Discussion of Groundwater Level Sustainability Management Criteria in the Final Colusa Subbasin GSP

March 11, 2022

Ken Loy, PG, CEG, CHG
West Yost

Groundwater Level Minimum Threshold Criteria in Final GSP

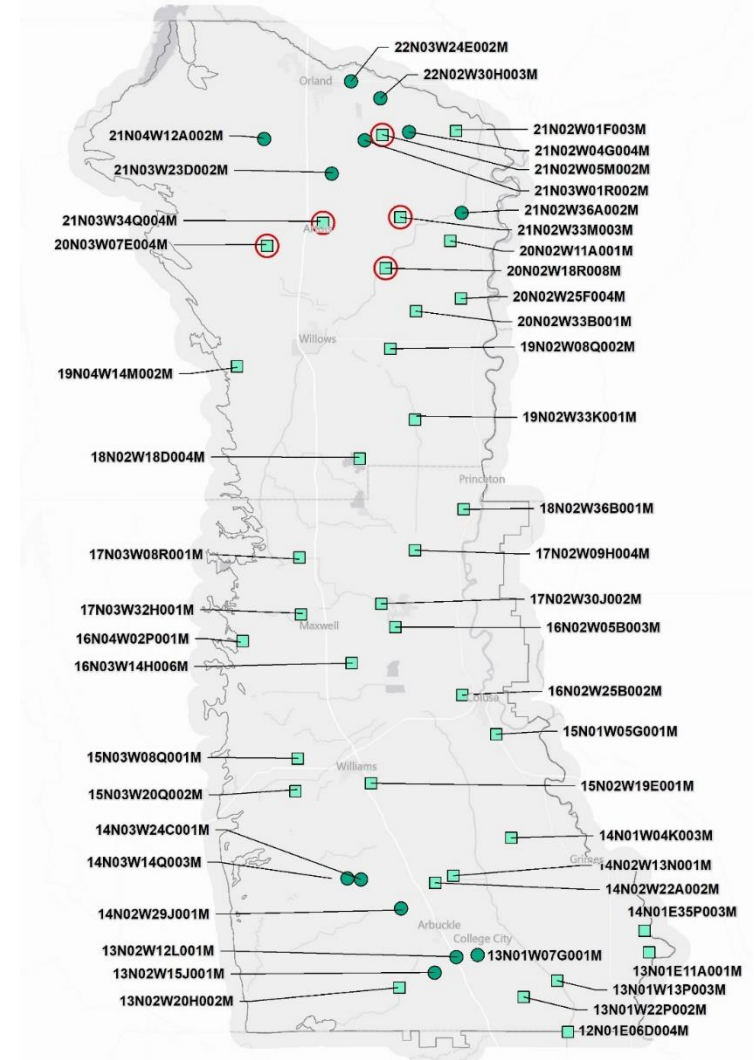
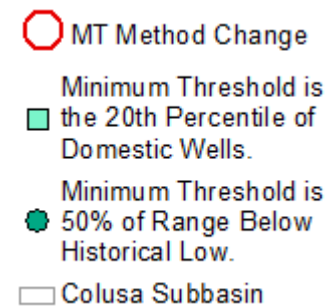
- Map shows methodology for each well, and
- Minimum threshold criteria changes in Final GSP
 - To 20th Percentile of Domestic Wells
 - From 50 Percent of Range Below Historical Low
- Changes in Final GSP are more representative and protective
- SMCs can be refined, and wells added to the network

Example Hydrograph of Well Near Orland, Glenn County

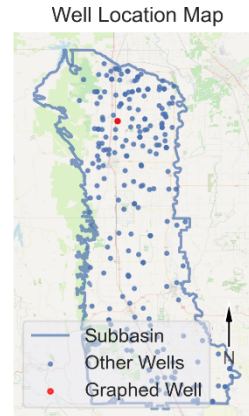
Original

- 21N03W34Q002
- MT: 221' bgs
 - 50% of Range Below Historical Low

Revised

- 21N03W34Q004
- MT: 125' bgs
 - 20th Percentile of Domestic Wells

Sustainable Management Criteria:

IM (2027) = 112.0 ft AMSL
 MO = 112.0 ft AMSL
 MT = 42.0 ft AMSL

Minimum Threshold is the 20th Percentile of Domestic.
 Sacramento Valley Water Year Index (WYI) shown on lower right. Meaning of colors defined below.
